HENDERSON COUNTY TECHNICAL REVIEW COMMITTEE

SUBJECT: Master Plan for Dodd Meadows Major Subdivision (File #2010-M03)

Henderson County Planning Department Staff Report

Master Plan Review for the Dodd Meadows Major Subdivision (File #2010-M03) Henderson County Habitat for Humanity, Inc.

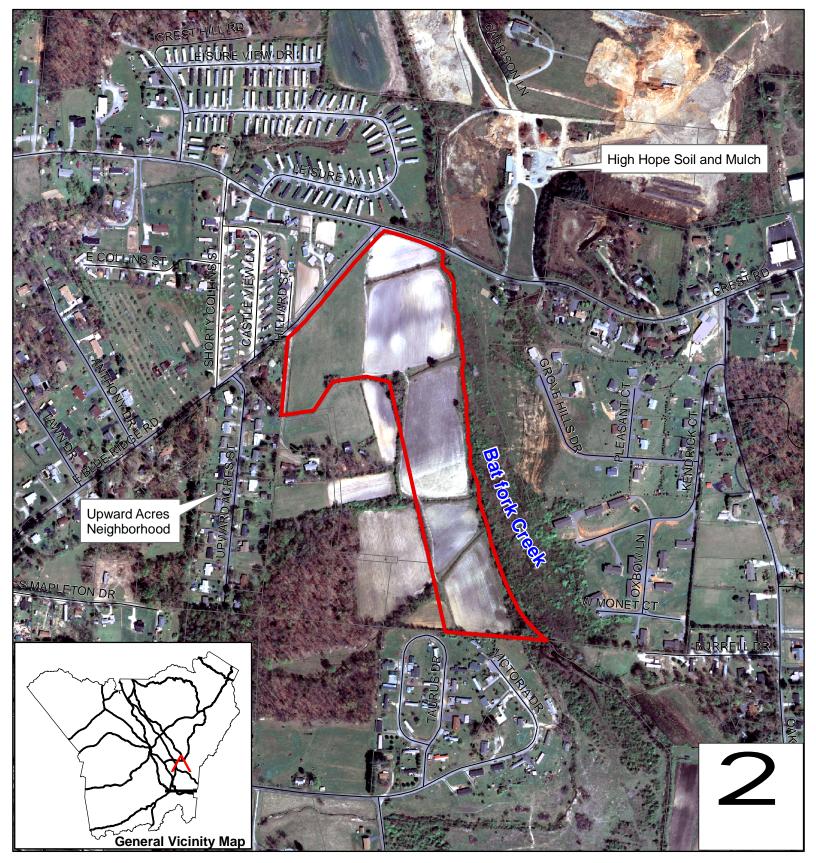
Staff recommends that the northern most road loop back into Volunteer Way and designated a one way road. This will limit road widths and construction costs, as well as, alleviate concerns with dead end roads. In order to avoid traffic problems staff also suggests placing the entrance of any one way road at the primary interior intersection of the development.

sheet <u>C-100</u>

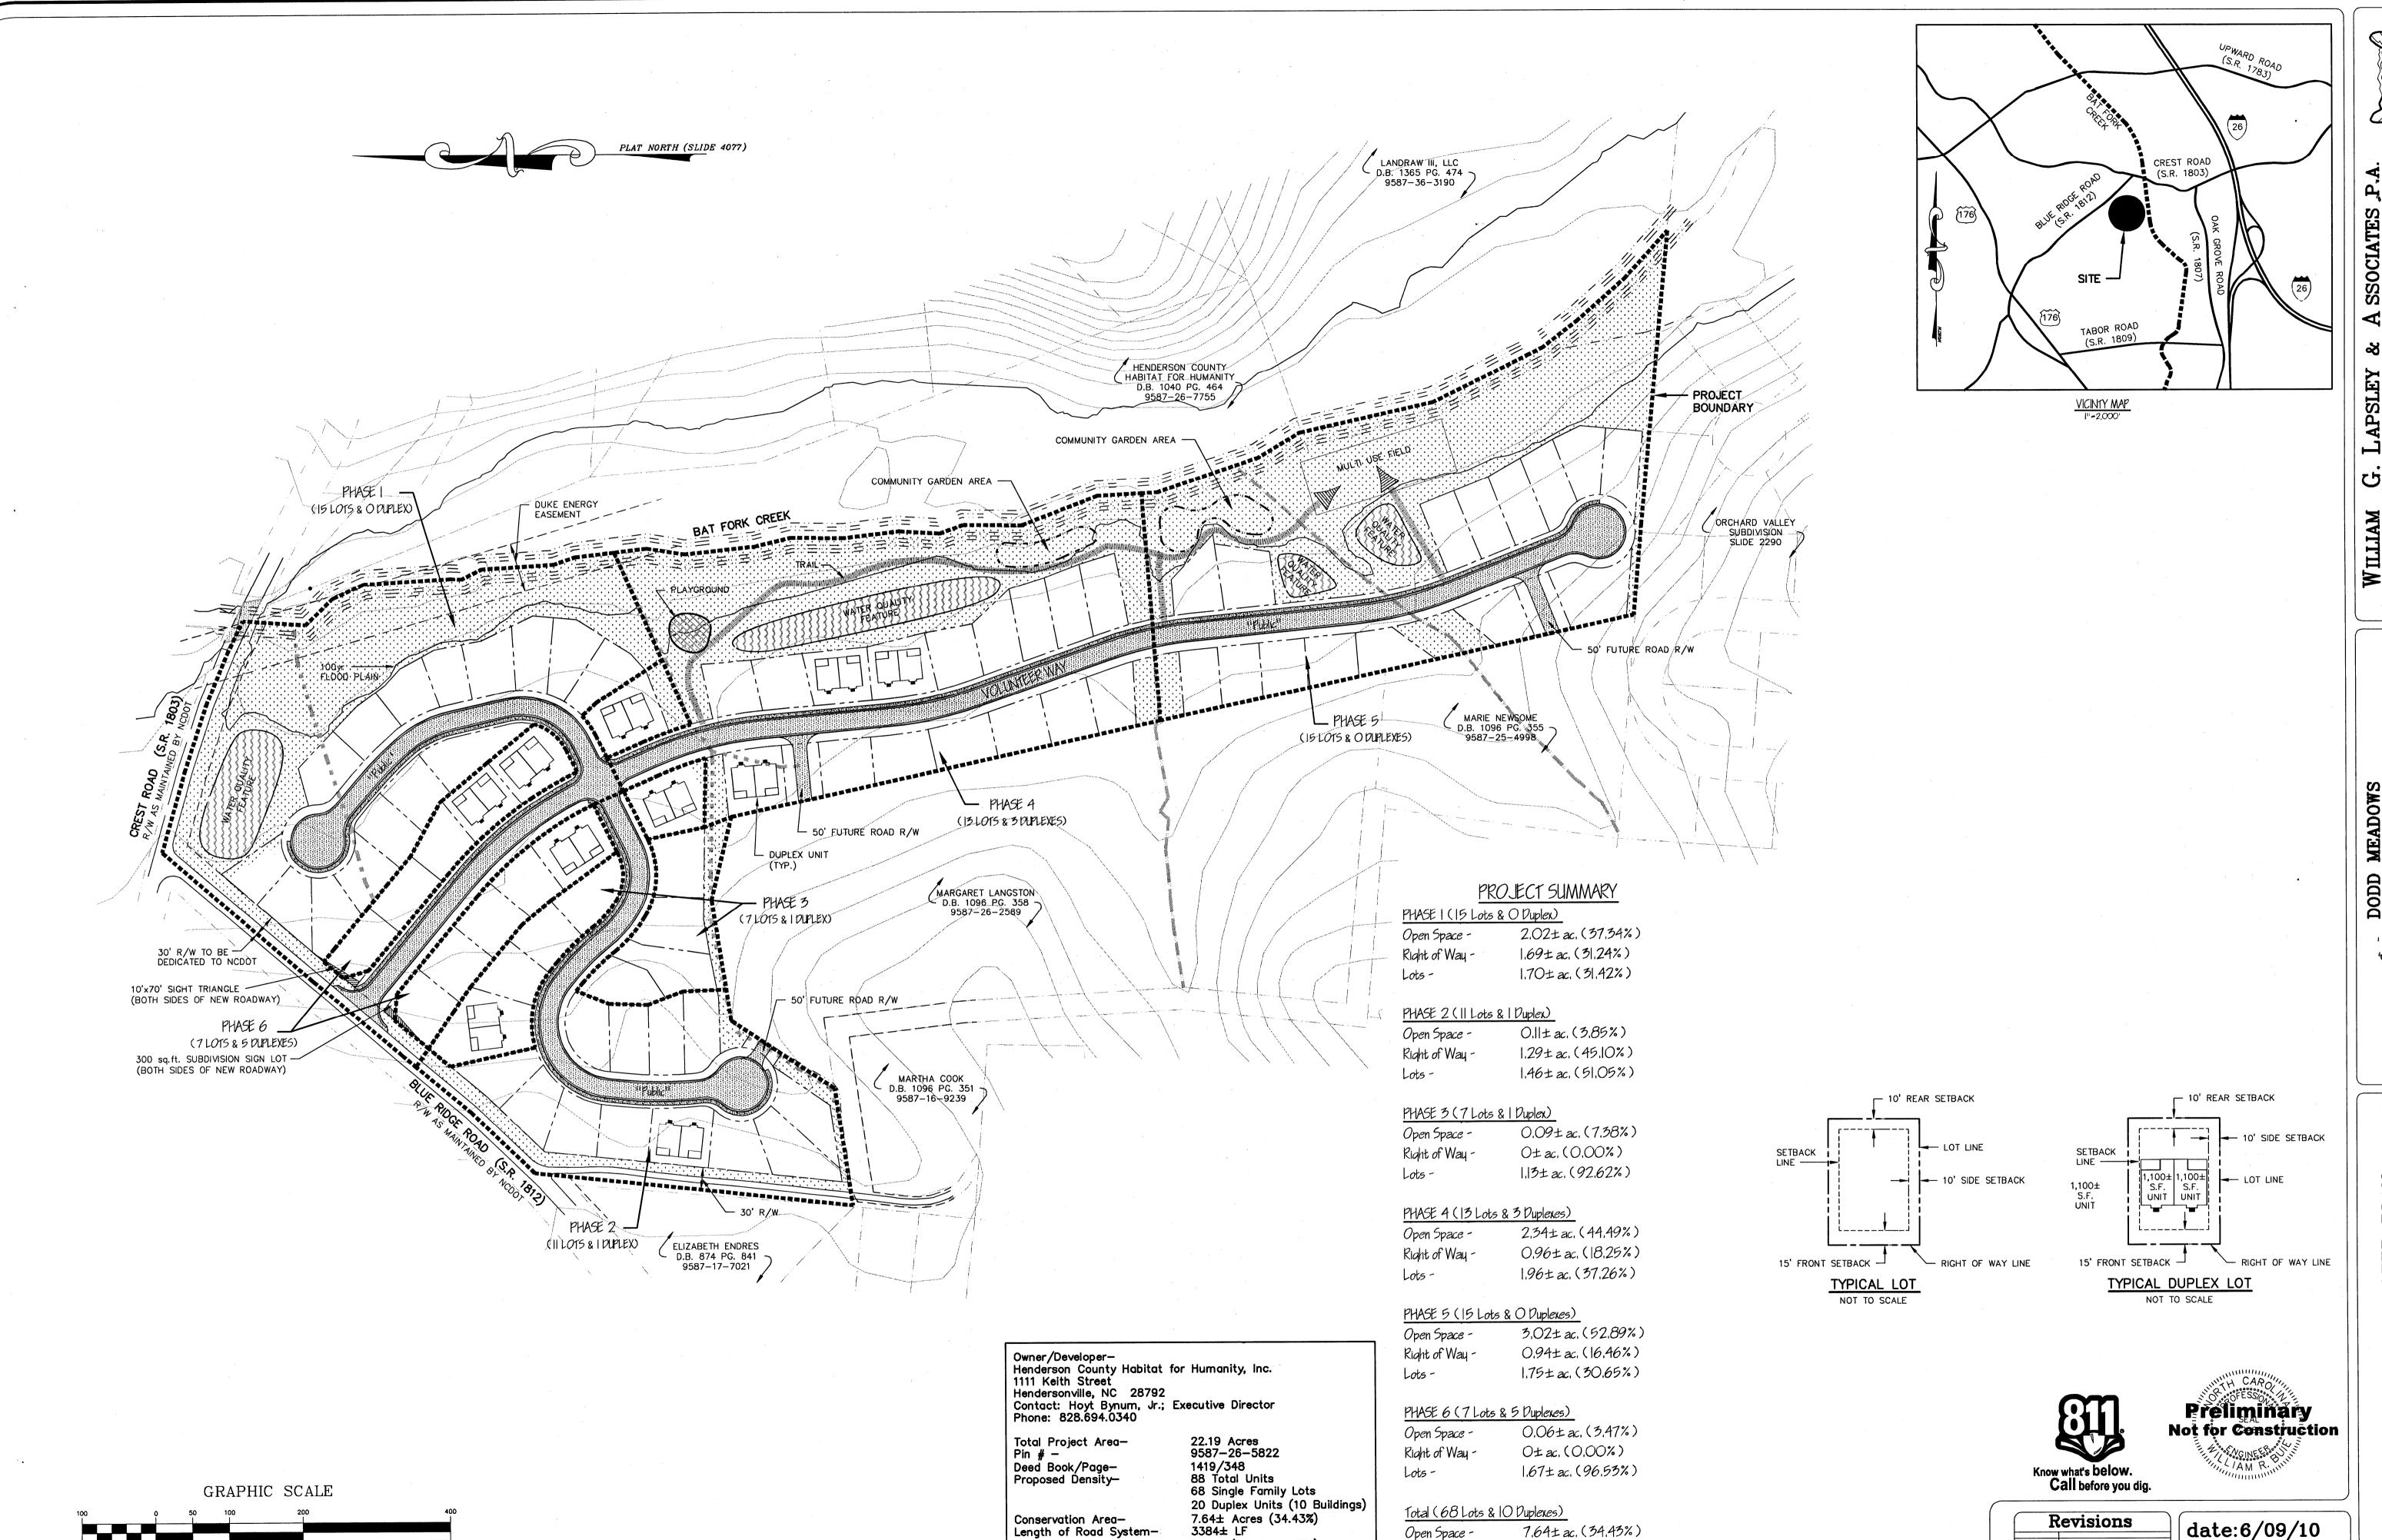
- 4. **Stub Roads and Future Connections.** The submitted Master Plan shows three future connections. Any existing or proposed on site rights-of-way must be built and constructed to the Major Subdivision road standards of LDC §200A-81C. The proposed stub roads must be constructed to the edge of the property line being developed to be considered a future connection (LDC §200A-81C).

- 8. **Conservation Subdivision Standards.** Of the approximate 21.19 acres within the project site, 34.7% (7.7 acres) is proposed as conservation area. This amount, more than meets the 25% conservation area requirement for the Conservation Subdivision Option in the Land Development Code and could qualify for a 10% housing density increase.
